# LEITNER-POMA SERVICE BULLETIN

Re: Omega lift Lateral rail entrances

## **SERVICE BULLETIN**

**Re:** Terminal entrance lateral rails

LATERAL RAIL ENTRY ANGLE ASSY

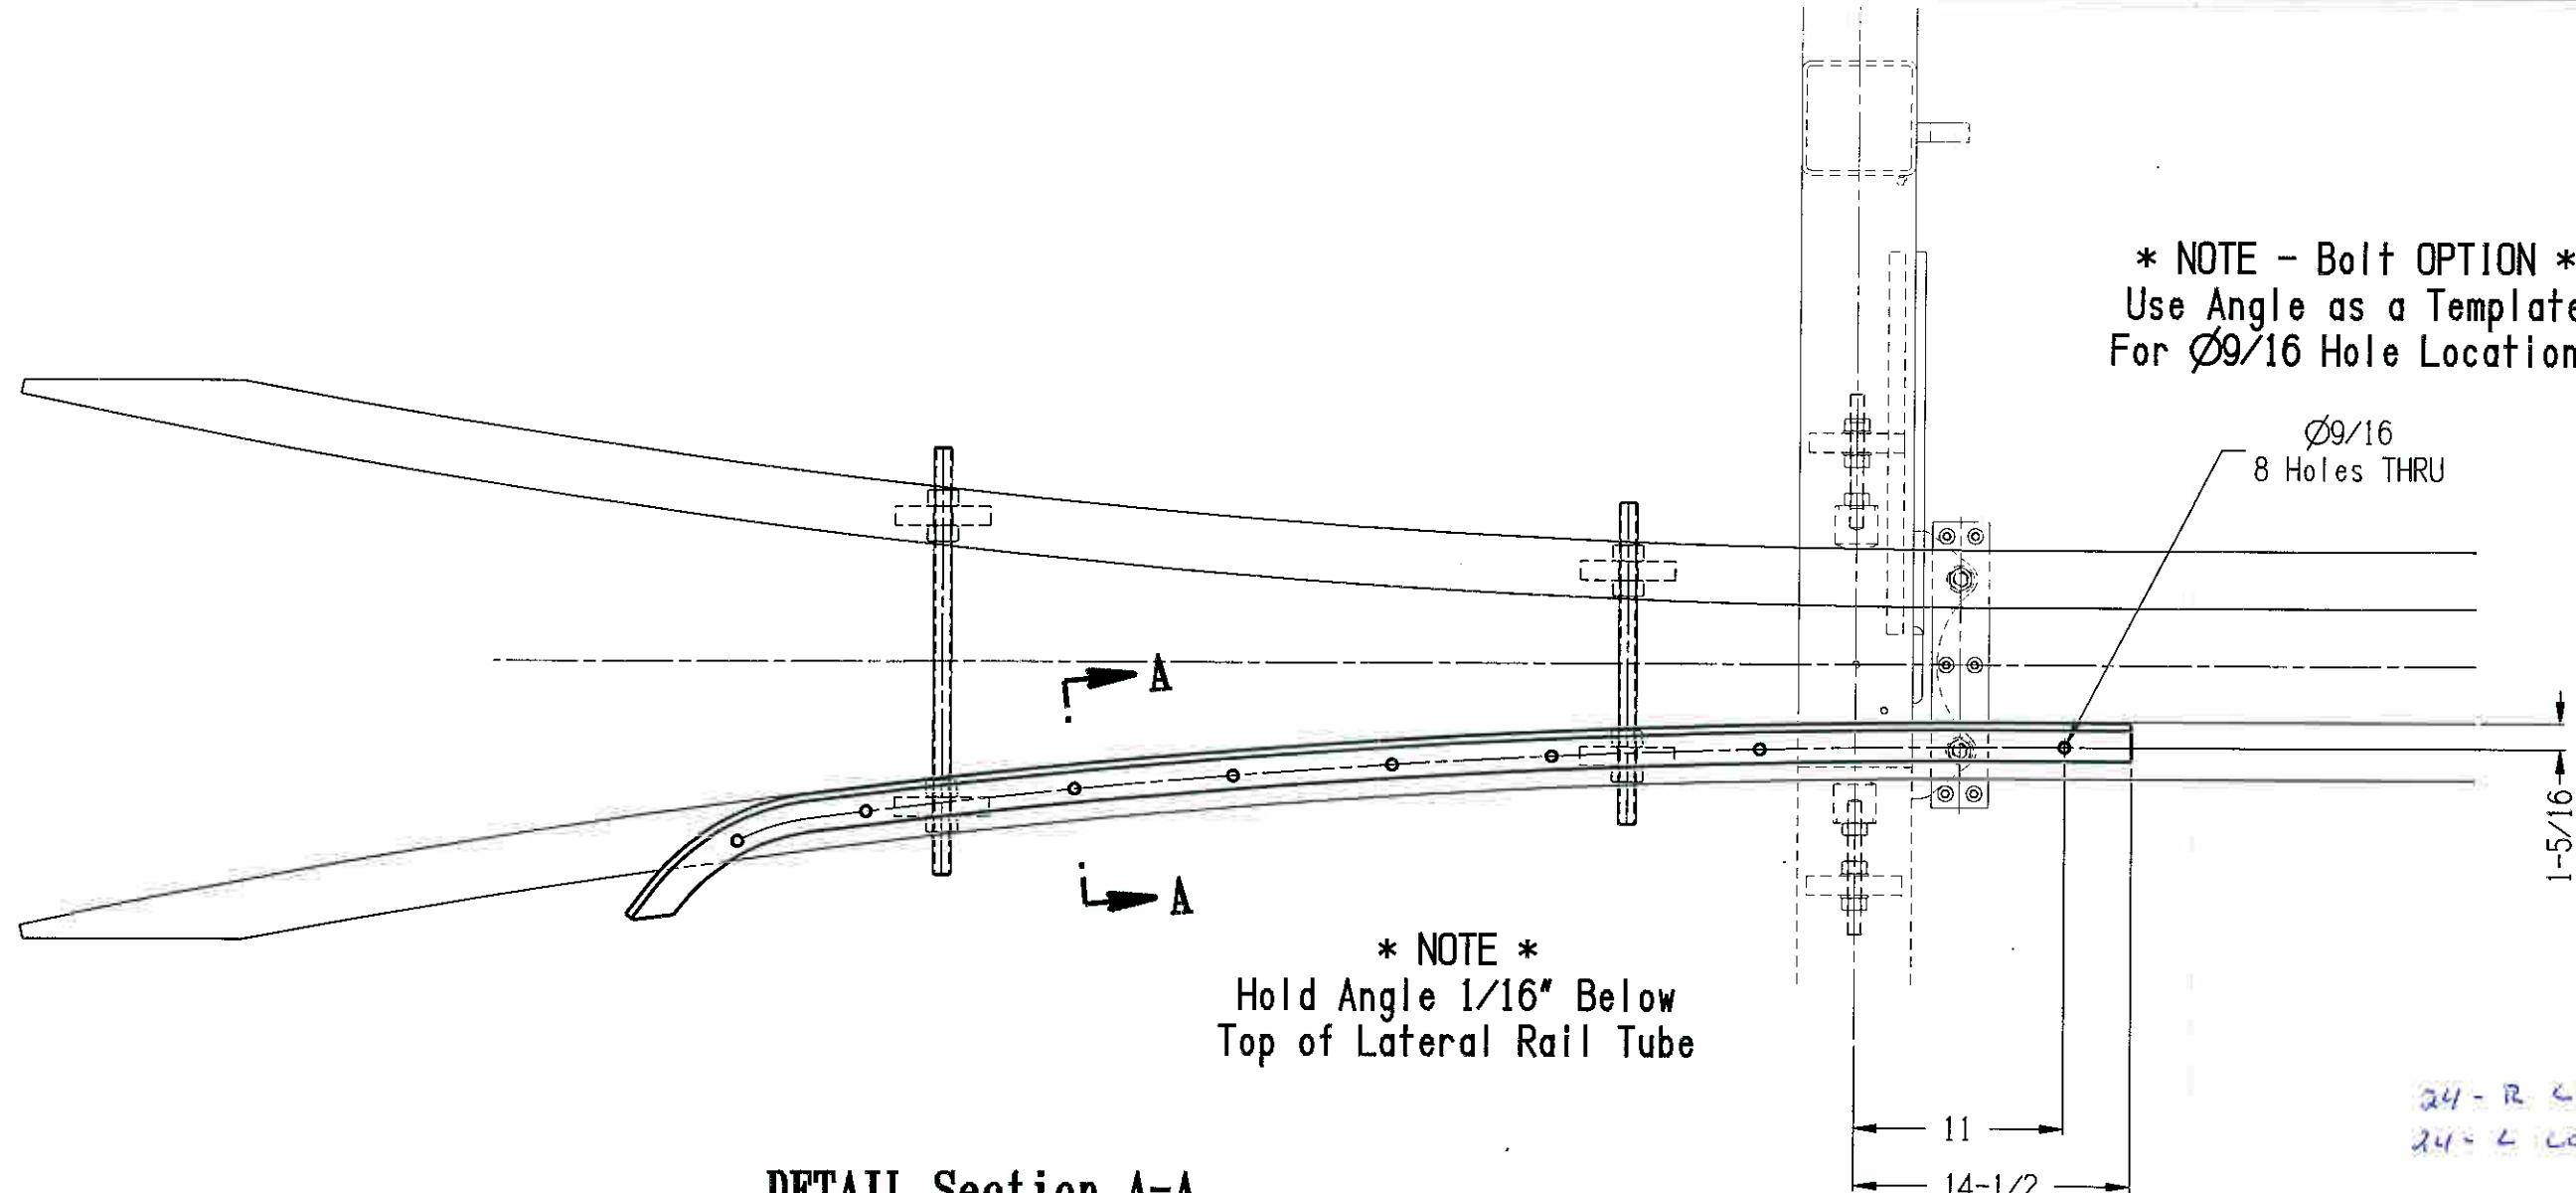
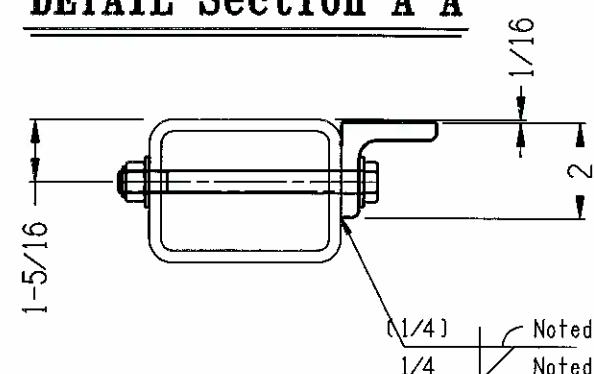
In an effort to improve safety and reliability of your lift, Leitner-Poma of America is requiring the installation of the new lateral rail entry angle assembly (3039.675).

The addition of the assembly will increase the ability of the lateral rail entrance trumpets to properly capture a grip during excessive carrier swinging conditions.

The accompanying drawing (3039.675) shows the mounting of the rail entry angle on a clock-wise lift, you will be sent free of charge the appropriate angle and hardware for your lift rotation. Please note that the addition may be mounted by drilling holes and using the bolts provided or welded in place, which ever works best for you. After installation please verify the trumpet is adjusted properly.

\* NOTE - Weld OPTION \*  
Step Weld with Minimum 1"  
Welds Above and Below Holes

A: MODIFY: Hole Layout ADD: Welding Option UPDATE: Notes  
REV: DESCRIPTION OF REVISION DATE: BY: 02/02/07 JMH
